# Planning Commission Work Session

January 31, 2023

# RZN22-0004 Glade Spring Crossing

**OVERALL CONCEPTUAL DEVELOPMENT PLAN**

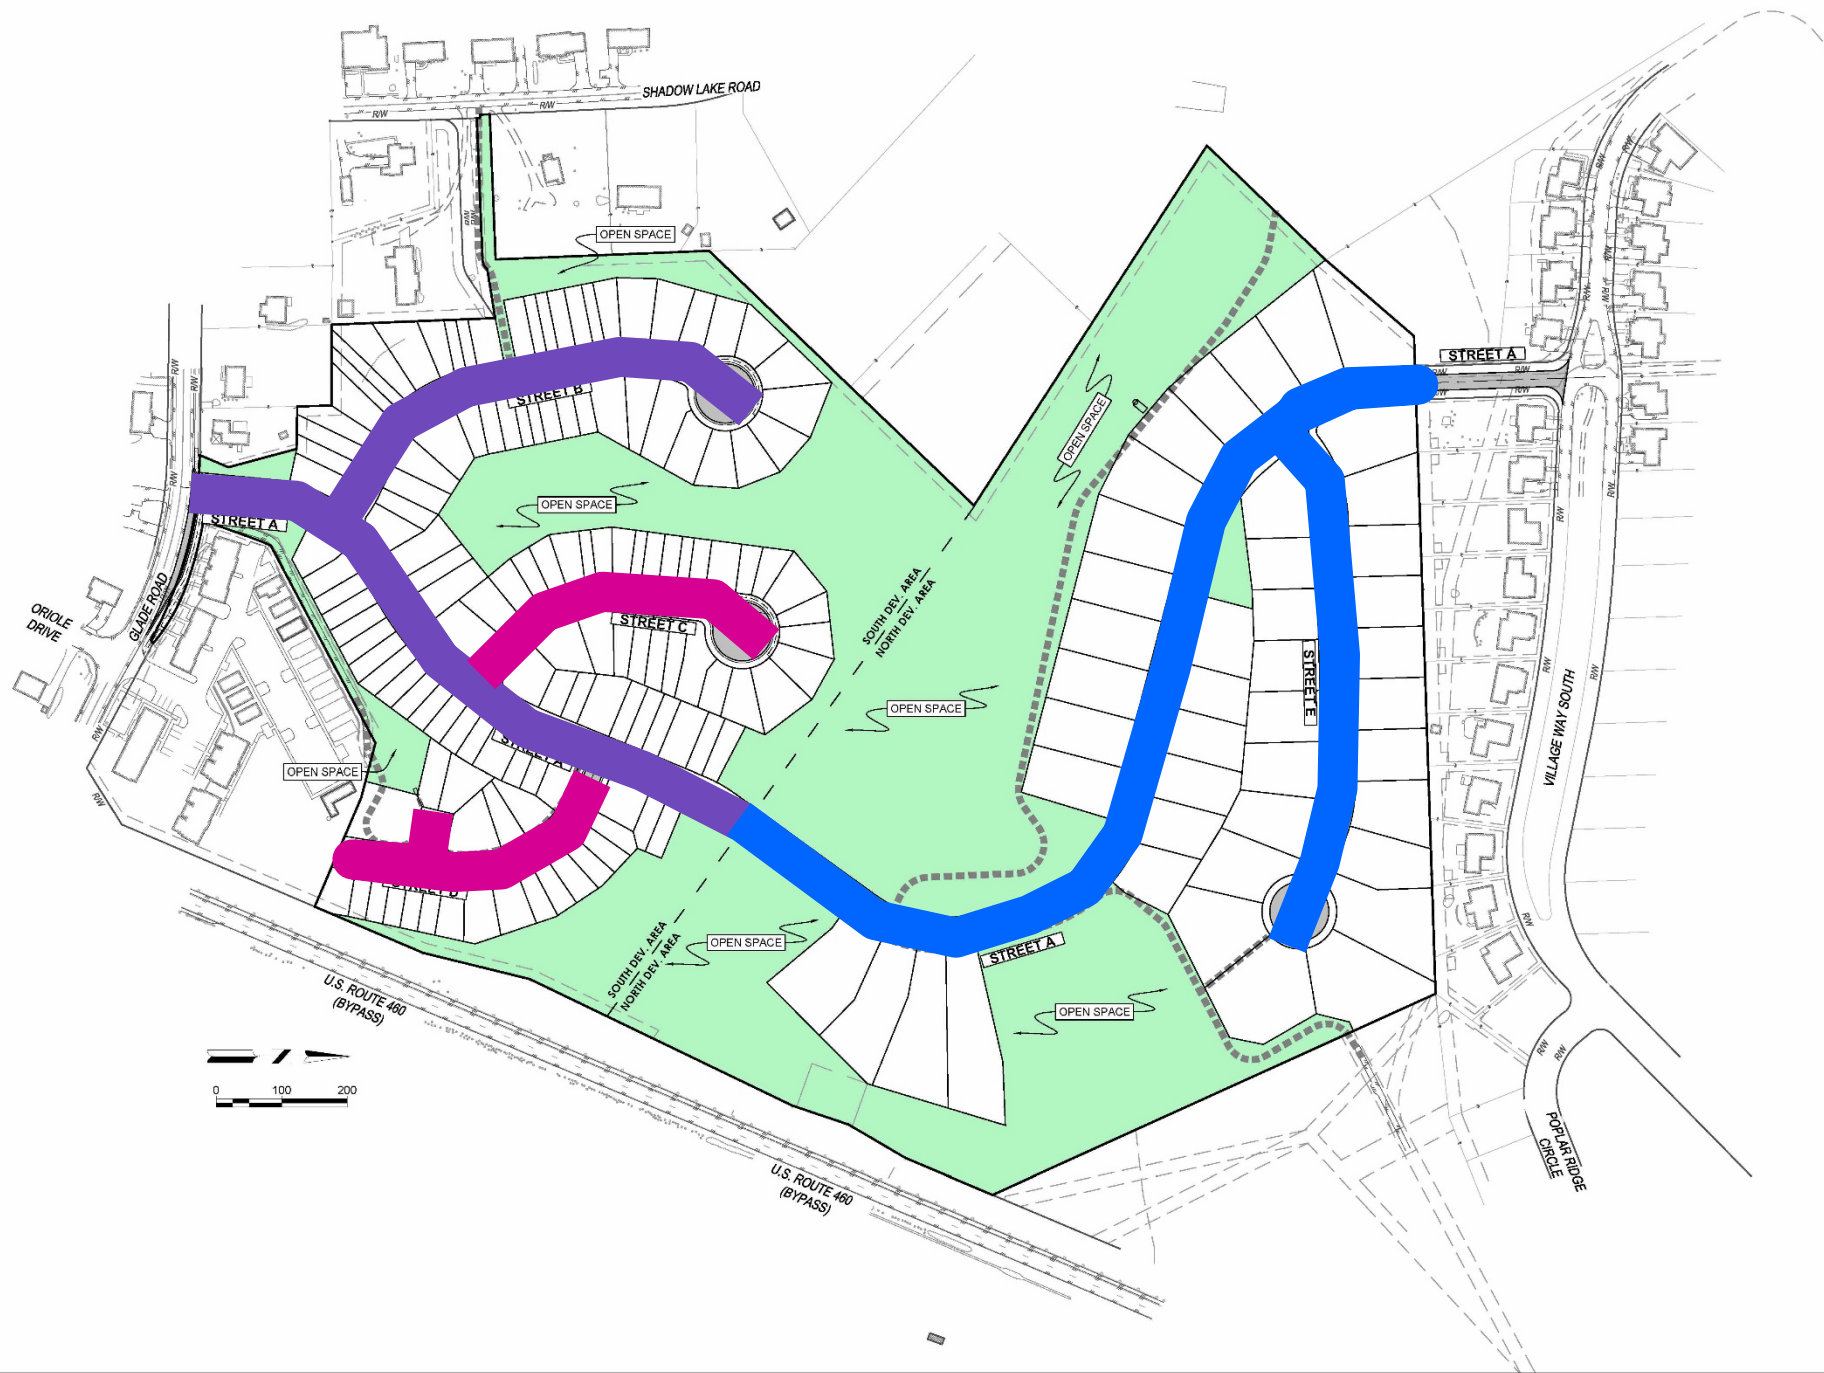
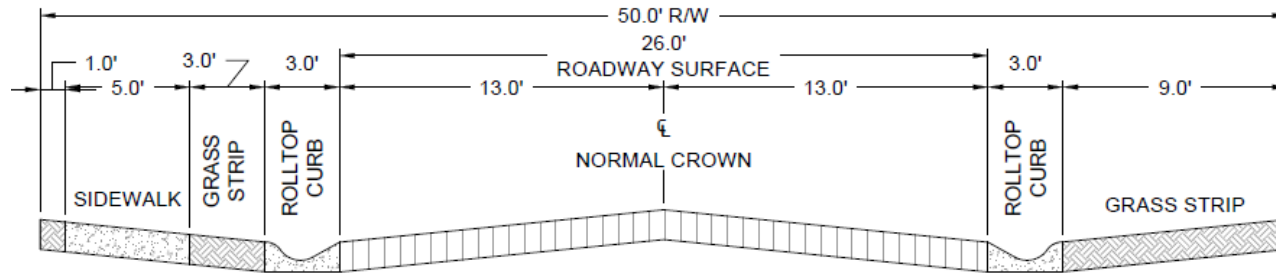
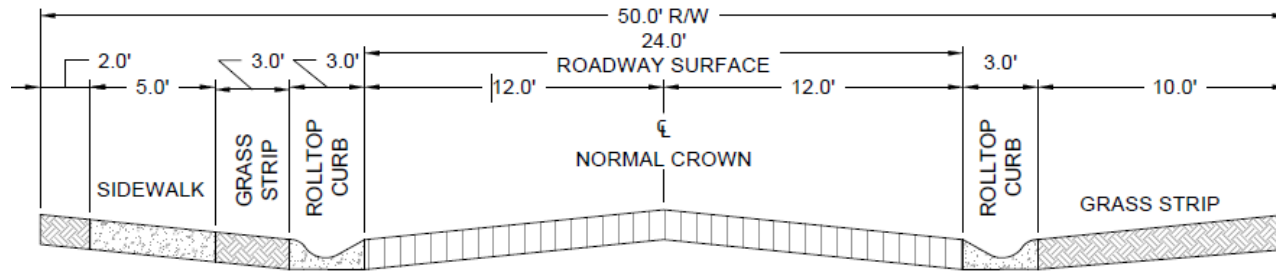
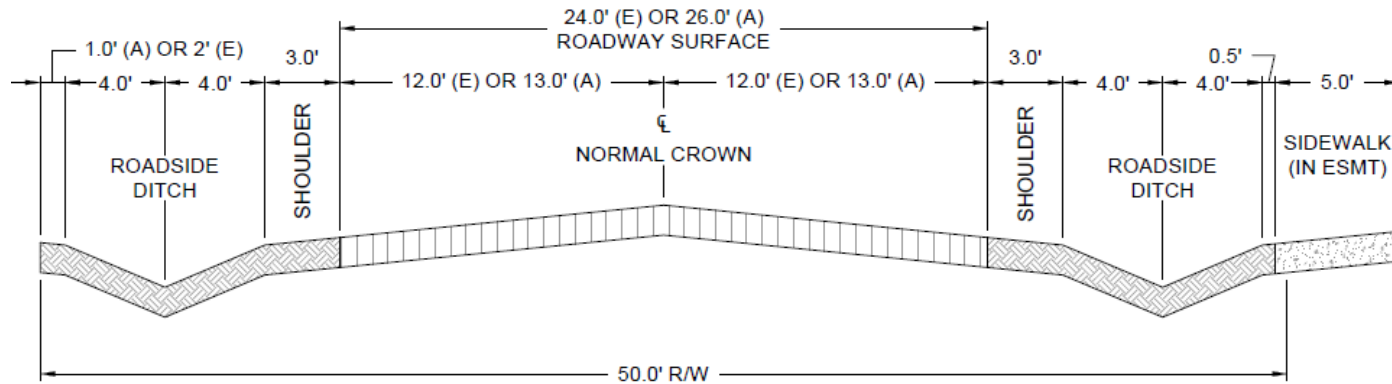
- Subdivision ordinance requires standard CG-6 curb & gutter on all new streets
- Applicant requests roll-top curb in south area; applicant requests no curb of any kind in north area—using roadside ditch for SWM
- Variance should be evaluated for appropriateness for both applications (north and south)

"DRIVEWAY MEASUREMENTS DIAGRAM"  
PER SEC. 5-318(d) OF SUBDIVISION  
ORDINANCE

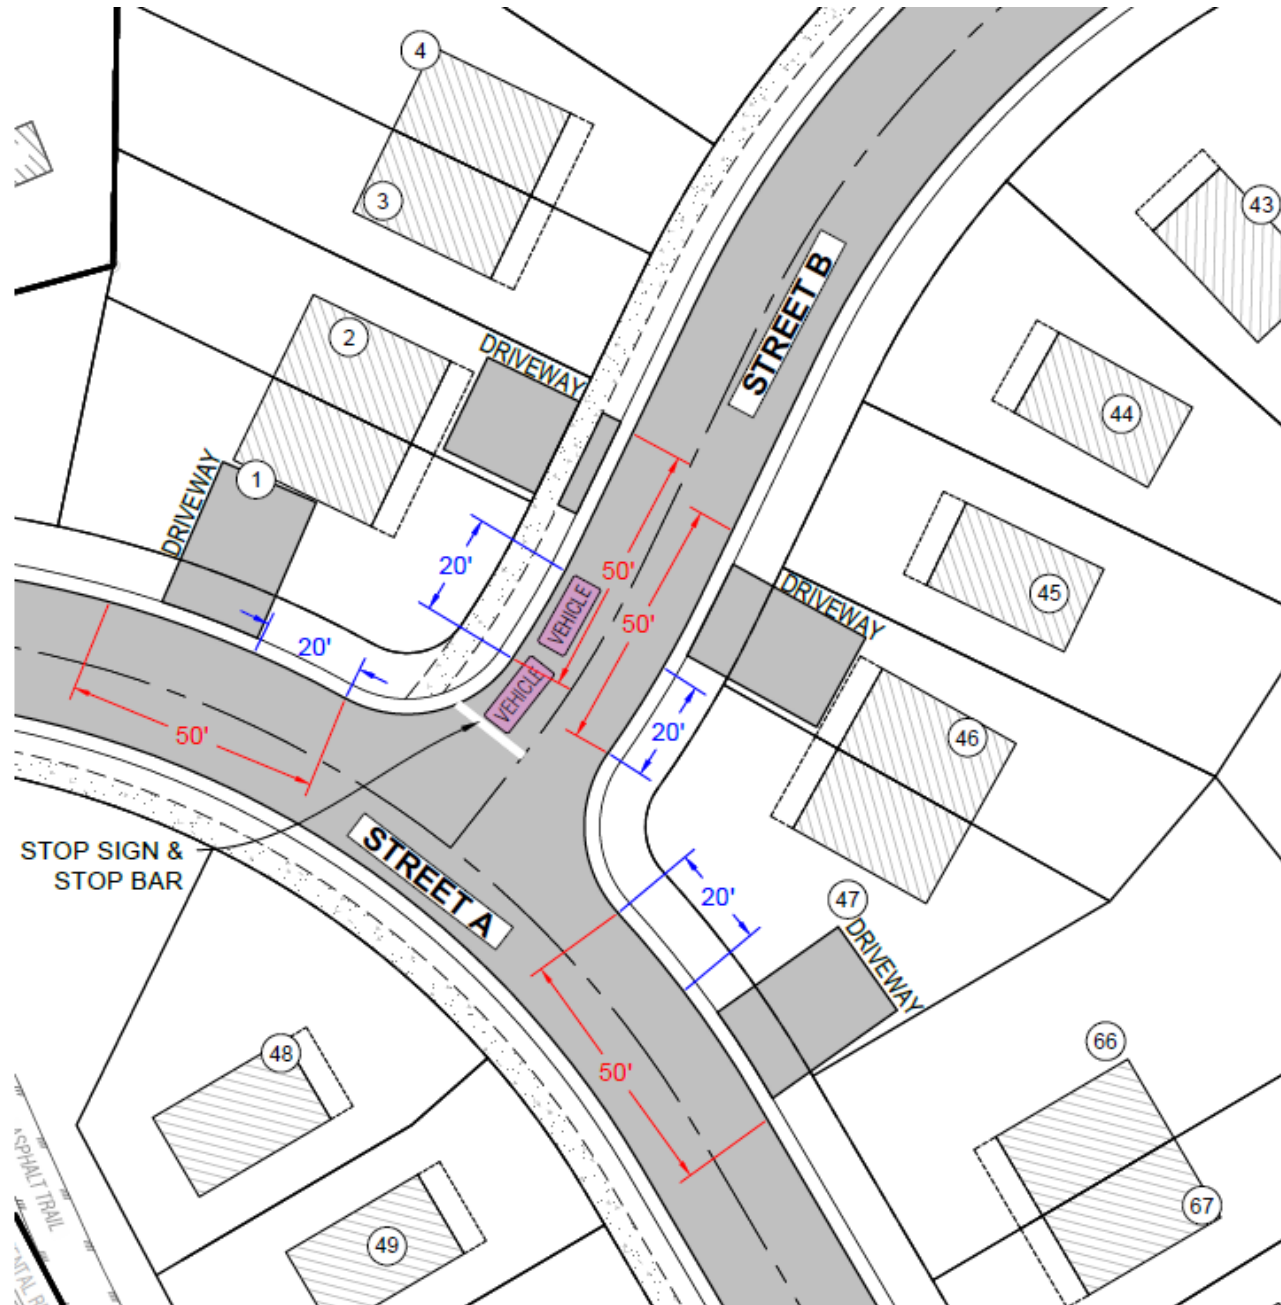
- Subdivision ordinance requires minimum distance from driveways to intersections
- Applicant requests closer distance due to small lot size

PROPOSED REDUCTION FROM 50' TO 20'

**PEDESTRIAN CIRCULATION AND TRAIL EXHIBIT**

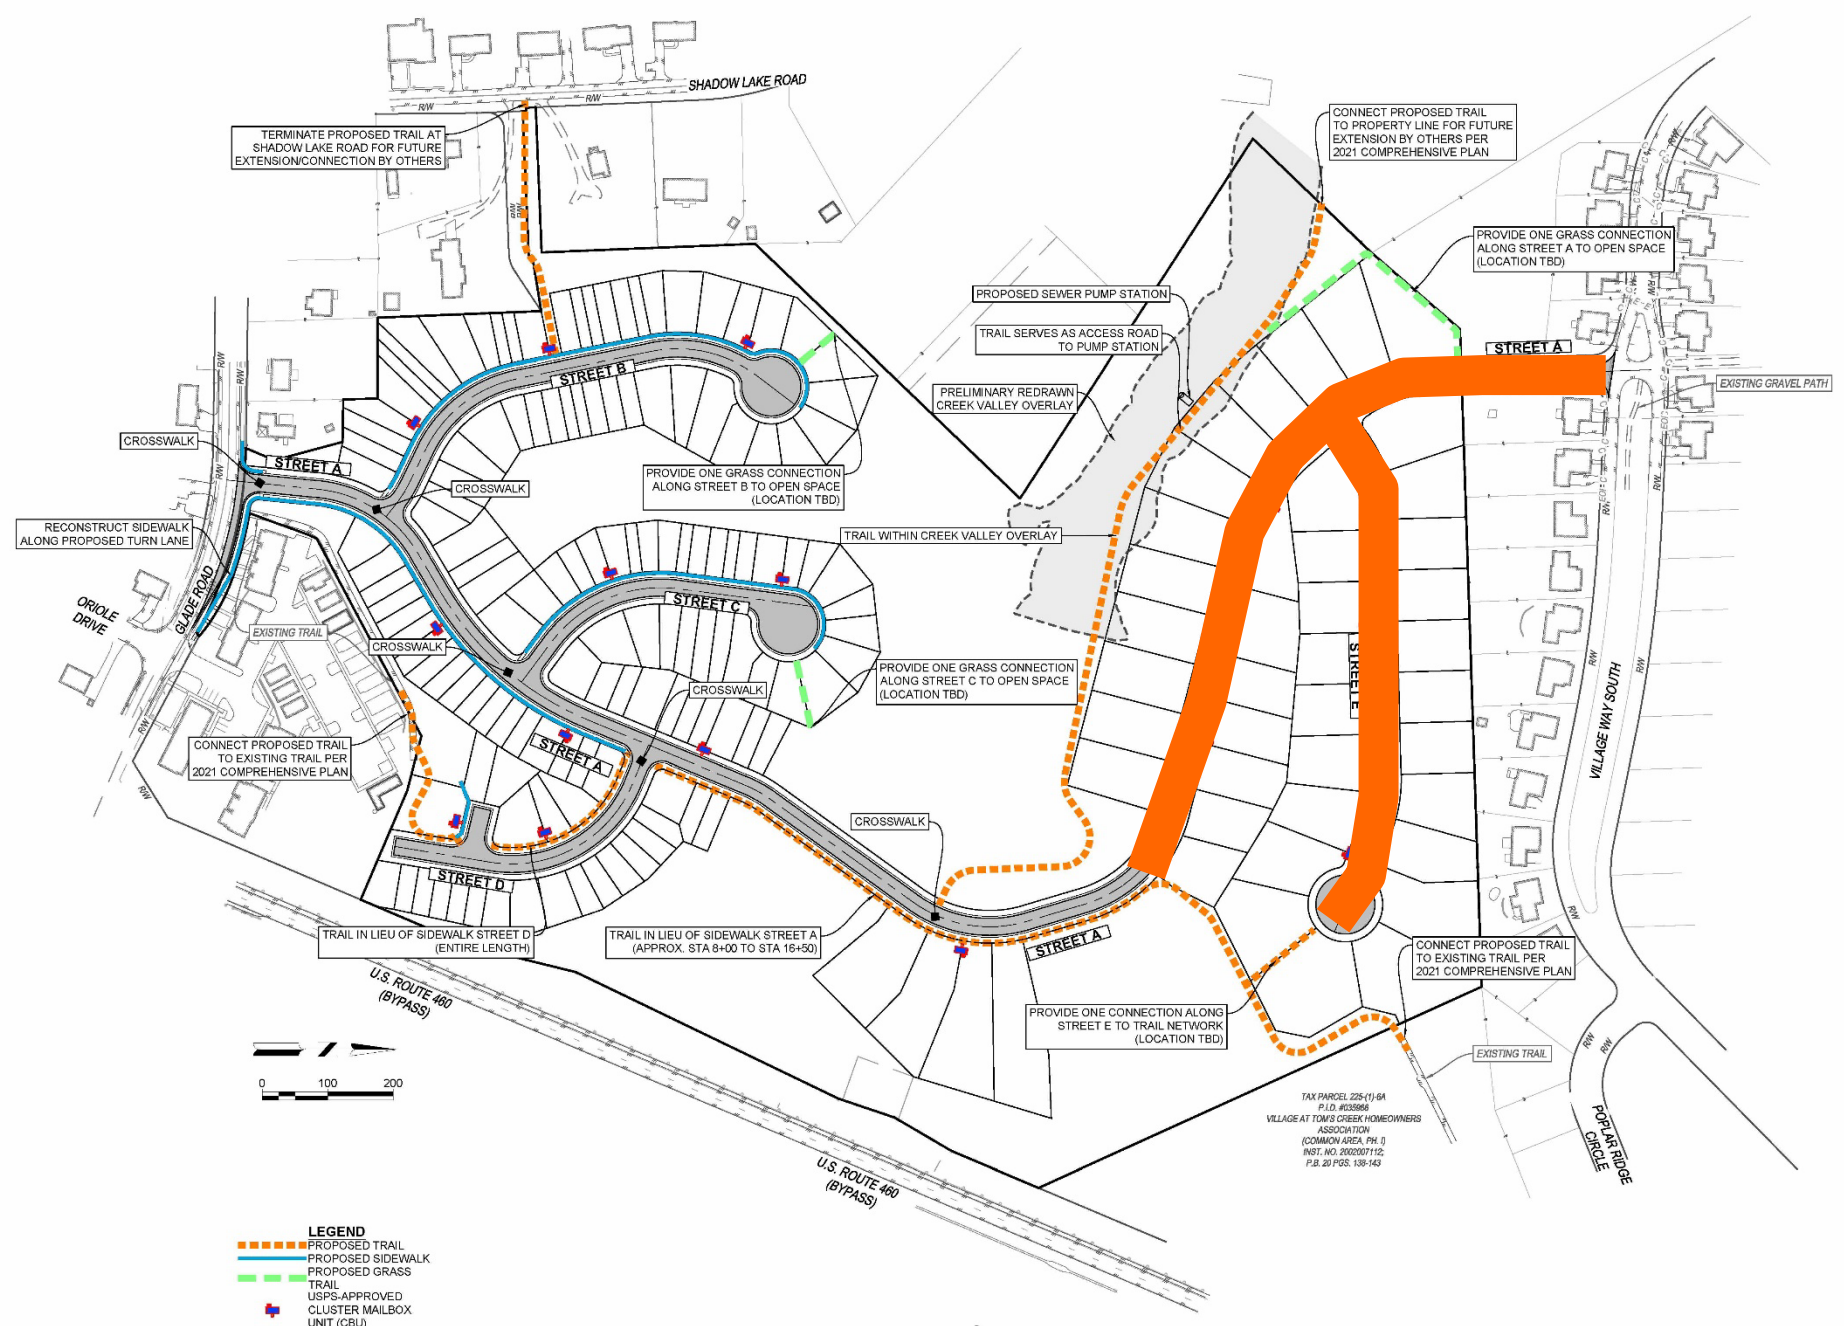
- Sidewalks are required along all new public streets; 5' concrete plus 4' vegetative strip
- Applicant requests to eliminate sidewalk in north area of development
